Access Compliance Report Public Rights-of-Way (Curb Ramps)

Intersection ID: 13683Main Street:ELIZABETH_AVCross Street:CHARLOTTETOWNE_AVLocation:WADA ID: 7C4A96CA30F4Ramp Type:PerpInitial Pass/Fail:FailOverall Compliance:NoSeverity Score:8.75

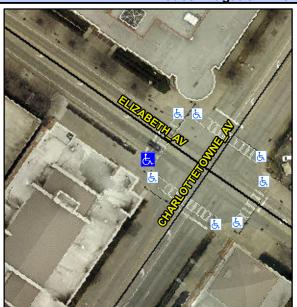
Possible Solutions:					
Remove & Replace Entire Ramp.					
Surveyor Notes:					
N/A					
PROW/ADA:					
Not Found, R304.5.1

Field Measurements/Component Compliance							
	Compliance Description		Data	Comp	liance Description	Data	
	N/A	Ramp Length (in)	84.0	Yes	Ramp Slope (%)	7.7	
	No	Ramp Width (in)	47.5	Yes	Ramp XSlope (%)	0.8	
	N/A	Flare Type LT	N/A	N/A	Flare Type RT	N/A	
	N/A	Flare Slope LT (%)	N/A	N/A	Flare Slope RT (%)	N/A	
	N/A	Flare Traversable LT?	N/A	N/A	Flare Traversable RT?	N/A	
	N/A	Landing Length (in)	N/A	N/A	DWS Provided?	N/A	
	N/A	Landing Width (in)	N/A	N/A	DWS Contrast?	N/A	
	N/A	Landing Slope (%)	N/A	N/A	DWS Length (in)	N/A	
	N/A	Landing X Slope (%)	N/A	N/A	DWS Full Width?	N/A	
	N/A	Landing Curb? (Y/N)	N/A	N/A	DWS Offset (in)	N/A	
	N/A	Shared Landing?	N/A				
	N/A	Gutter Ponding?	N/A	N/A	Gutter Slope (%)	N/A	
	N/A	Gutter Lip Ht (in)	N/A	N/A	Gutter X Slope (%)	N/A	
	N/A	Painted X Walk1?	Yes	N/A	Painted X Walk2?	N/A	
		X Walk 1 Direction	To NE		X Walk 2 Direction	N/A	
	N/A	X Walk 1 Width (in)	106.0	N/A	X Walk 2 Width (in)	N/A
